**DOCKET NUMBER 50-483
CALLAWAY PLANT
RESPONSE TO REQUEST FOR ADDITIONAL INFORMATION
CONCERNING THE REVISION TO TECHNICAL SPECIFICATION
3/4.8.1, A.C. SOURCES**

Response to Request for Additional Information

Figure 1
Typical Full-Load Rejection Test
(Page 1 of 1)

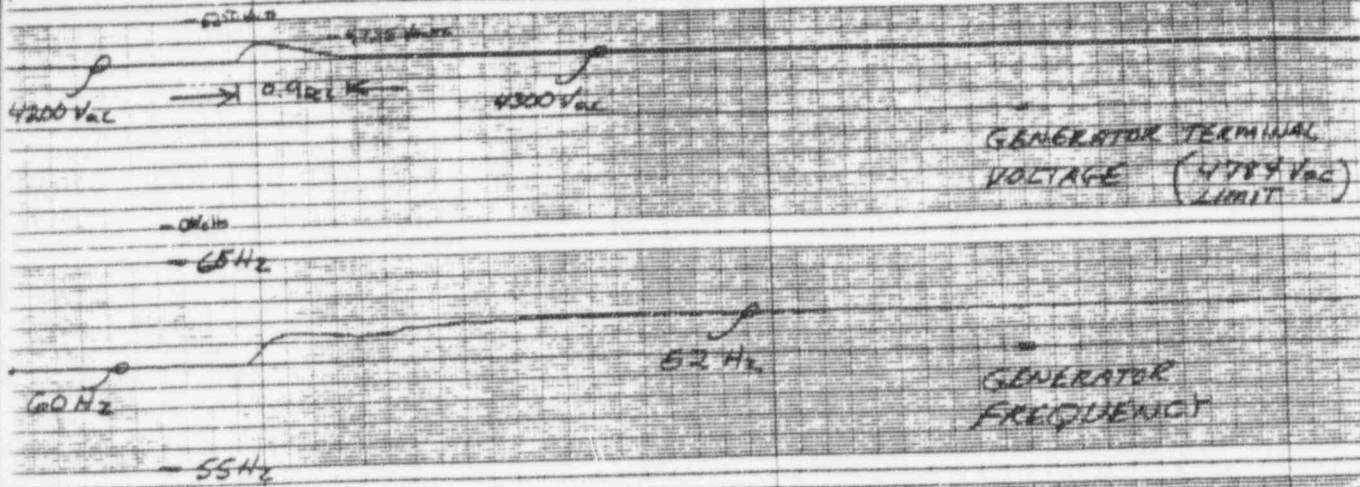
Provide additional justification for removal of Surveillance Requirement 4.8.1.1.2g.2 [4.8.1.1.2f.2], single-load rejection test, from Technical Specifications.

A. The single-load rejection test is enveloped by the full load rejection test since the proposed change revises the frequency criteria to 60 ± 5.4 Hertz which is the current frequency for the single largest load rejection test. Figure 1 provides a strip chart recording for the Callaway Plant for a typical full-load rejection test. Figure 2 provides a recording for Wolf Creek Generating Station (WCGS) of a typical full-load rejection test.
